Contract No. CV/2017/02

Development of Columbarium at Sandy Ridge Cemetery – Infrastructural Works at Man Kam To Road and Lin Ma Hang Road

Submission under Environmental Permit (EP-534/2017/A) – Condition 2.15 - 2.17 (Submission of Vegetation Survey Report and Transplantation Proposal (By Qualified Ecologist) – Revision 5)

Vegetation Survey Report and Transplantation Proposal

Slope profile_3NW-C/C230

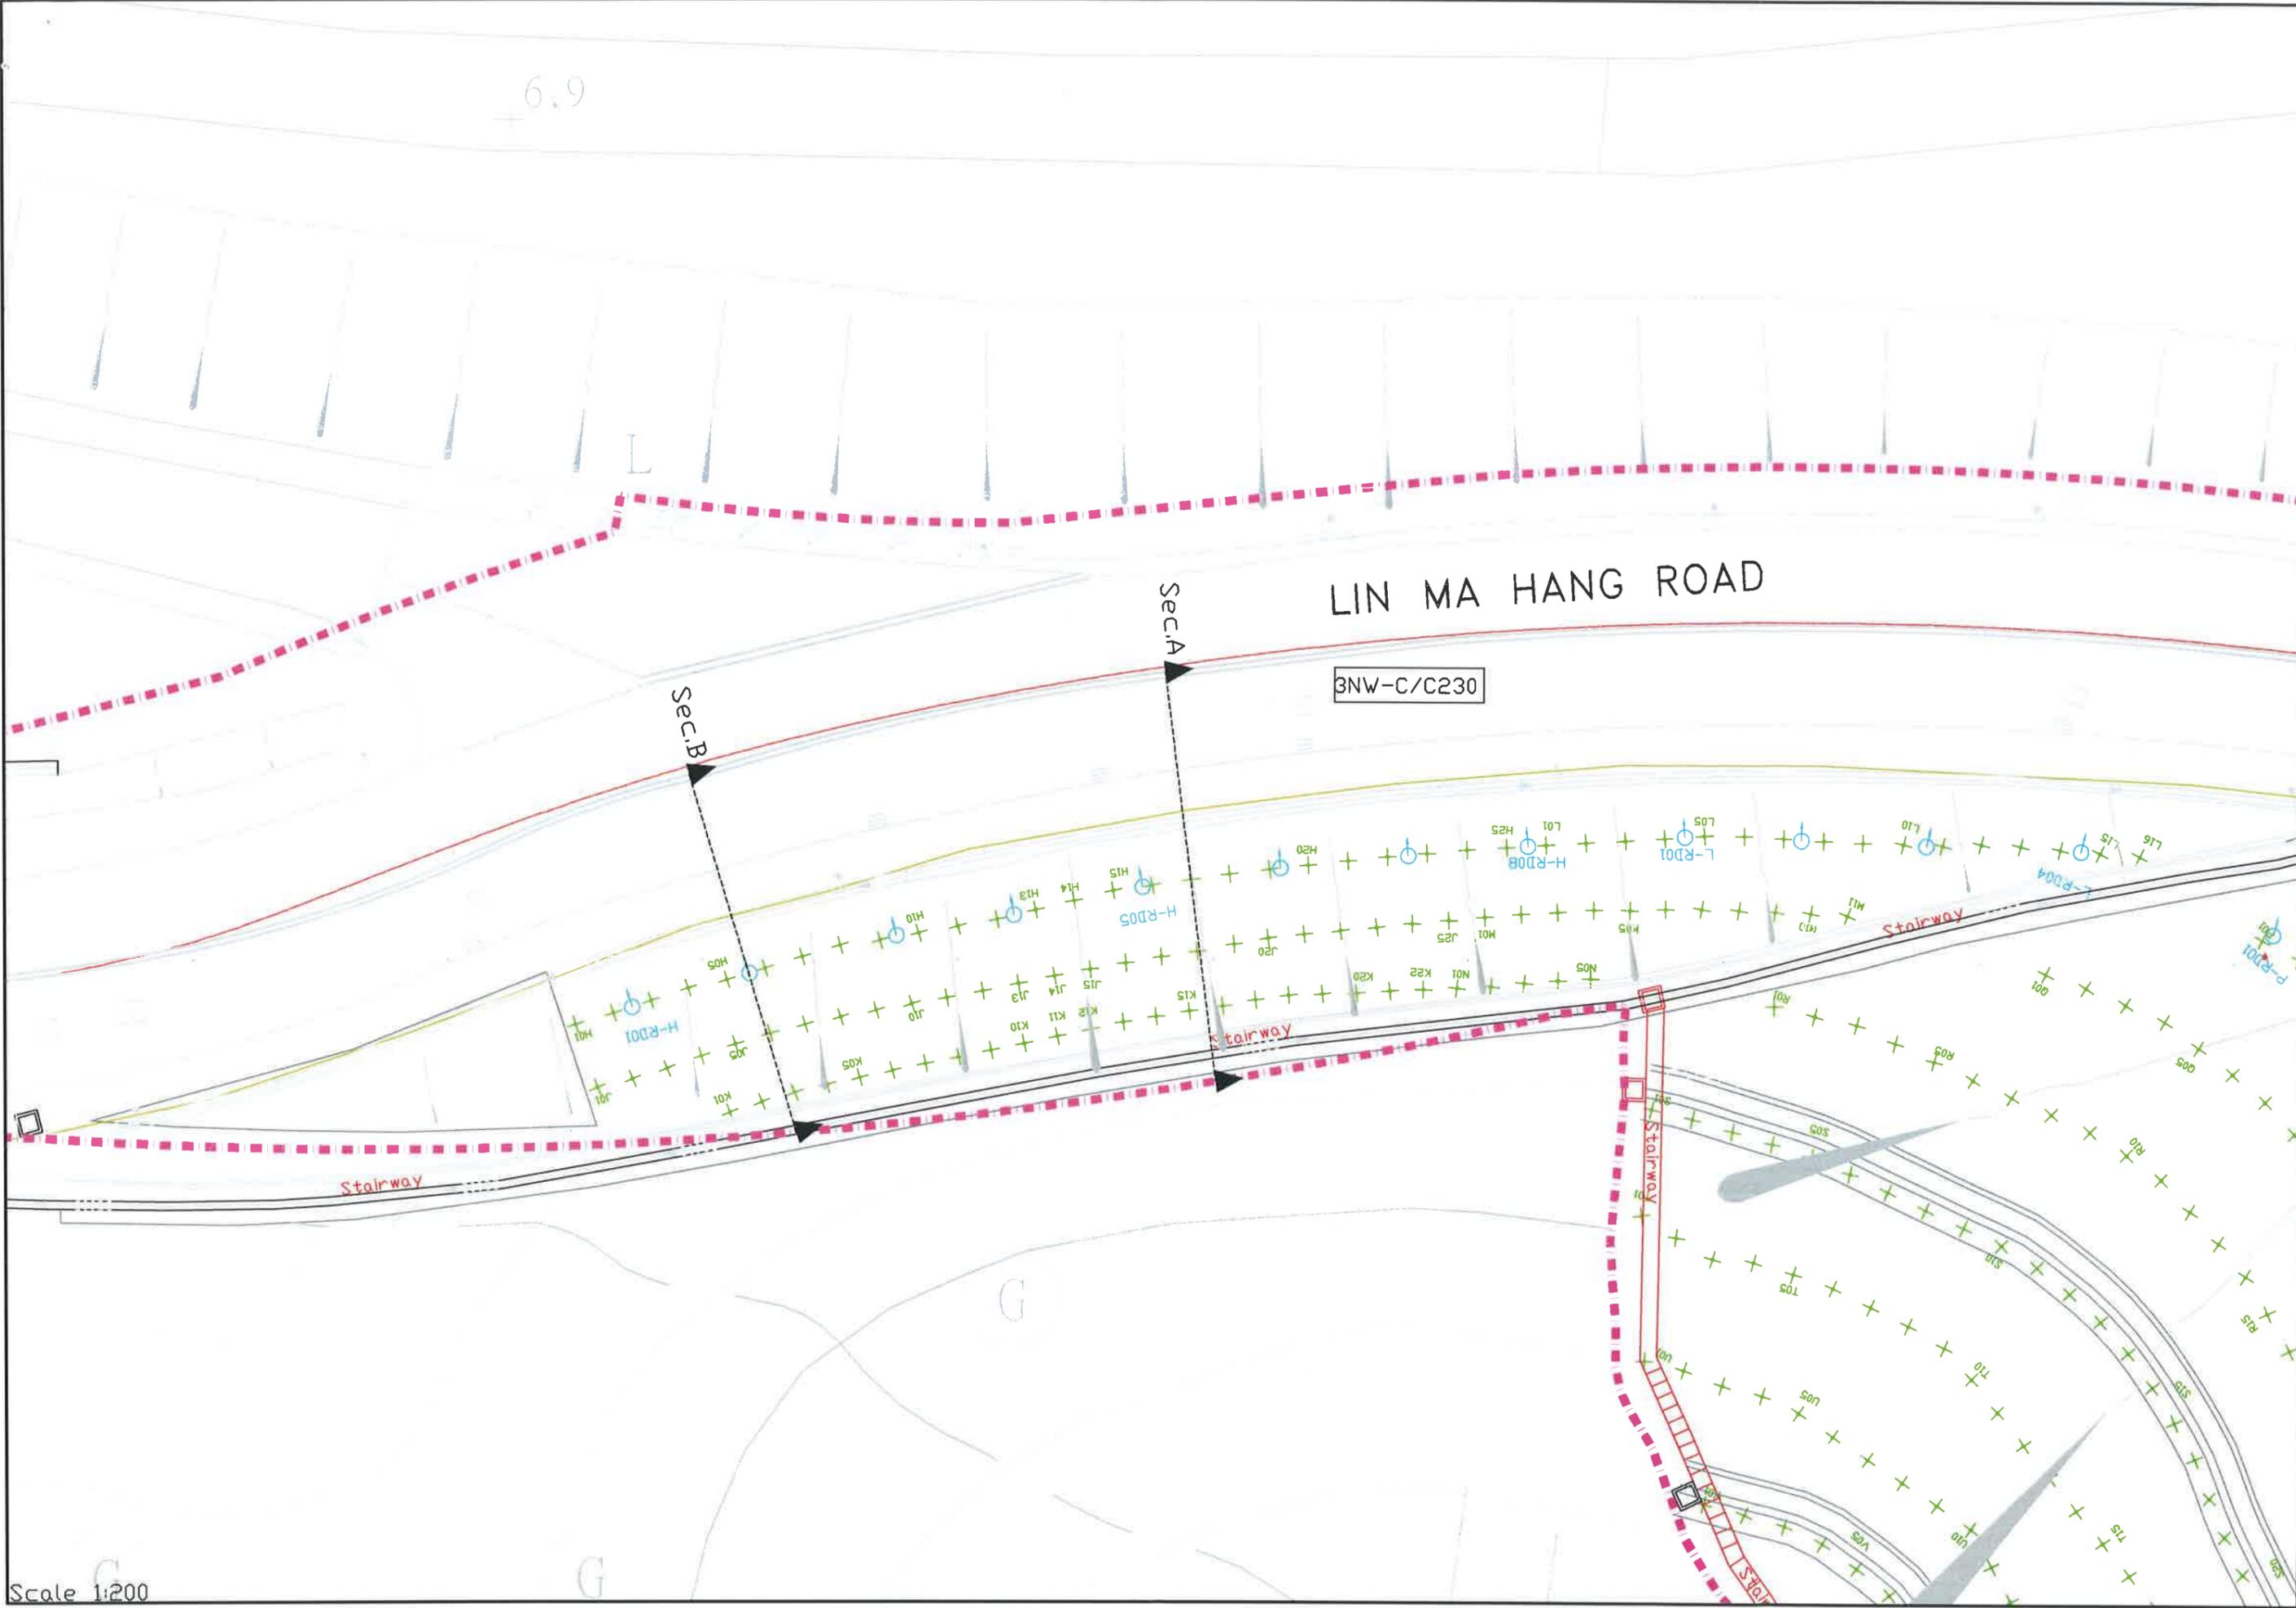
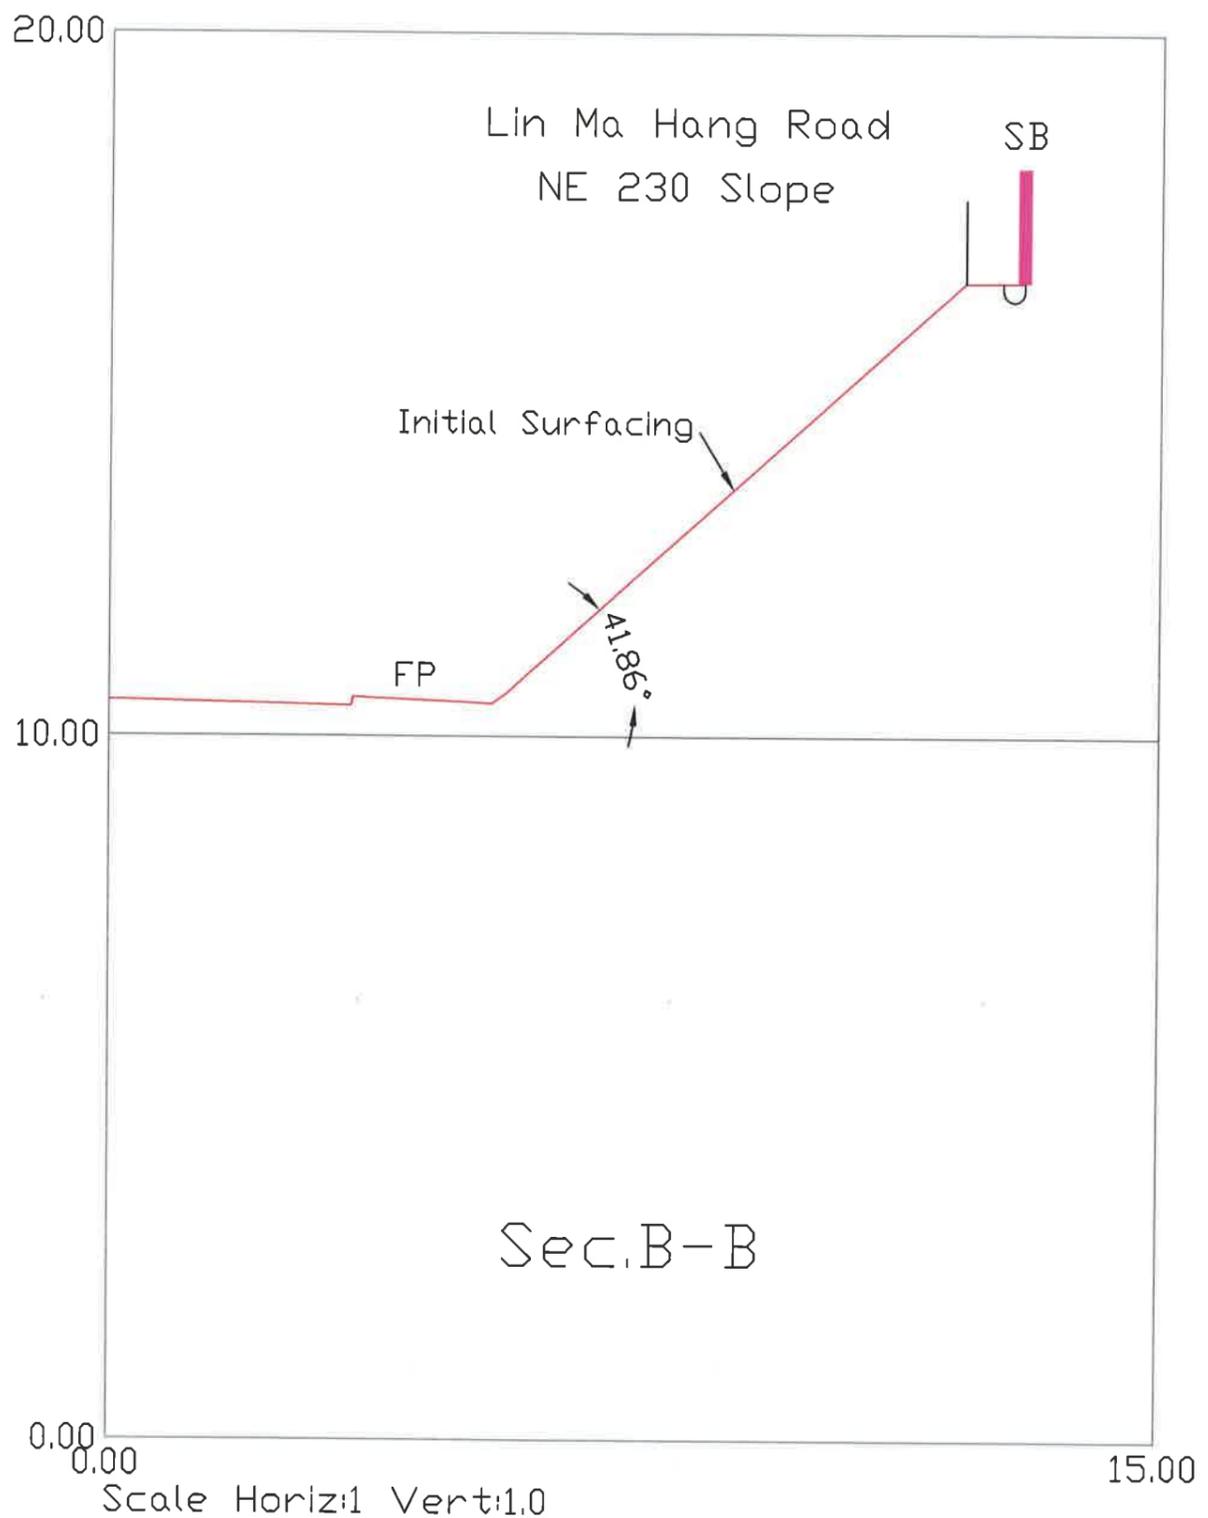
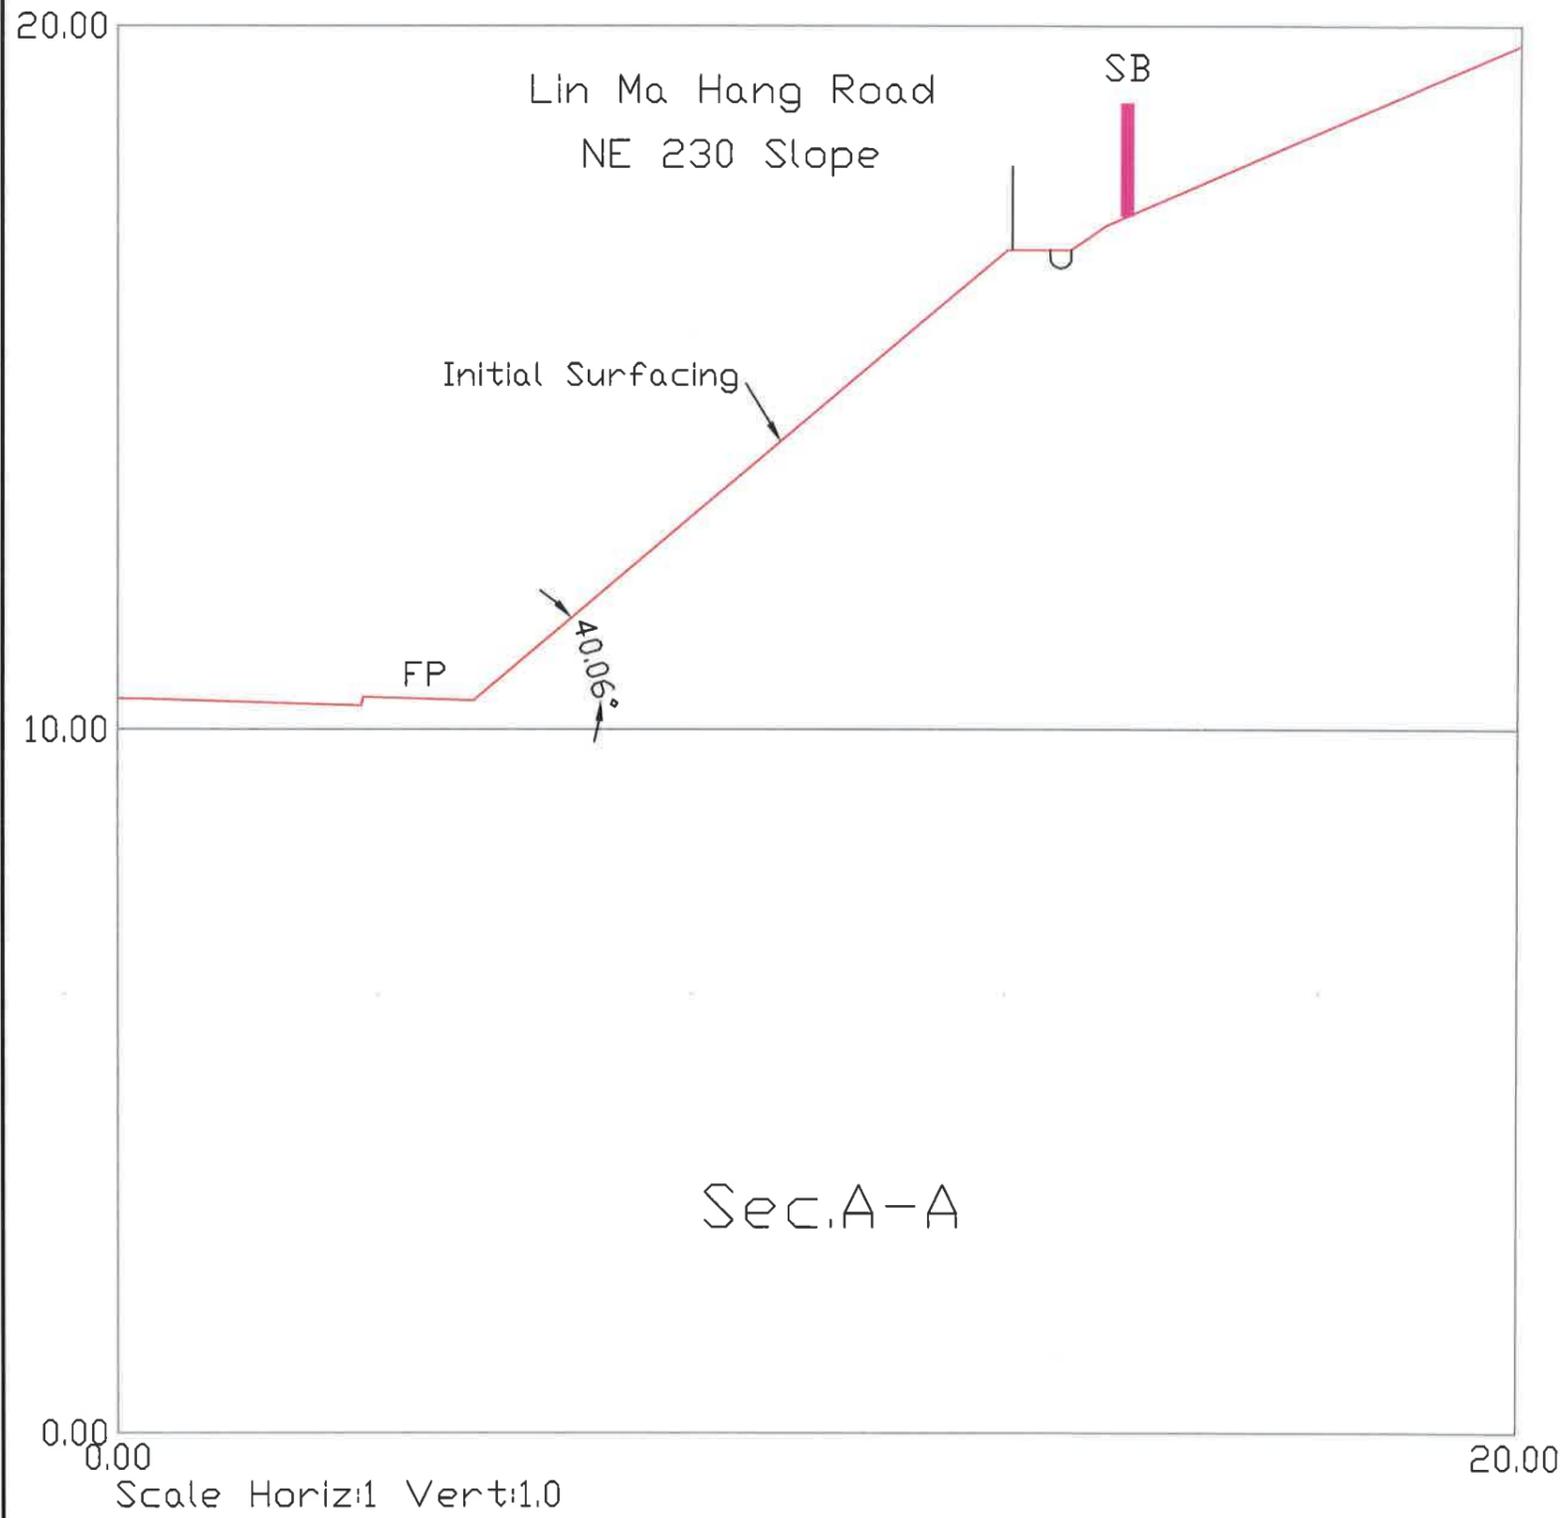
<p>d. Please update Appendix H to show the location of the concerned species in the figure.</p>	<p>Updated</p>
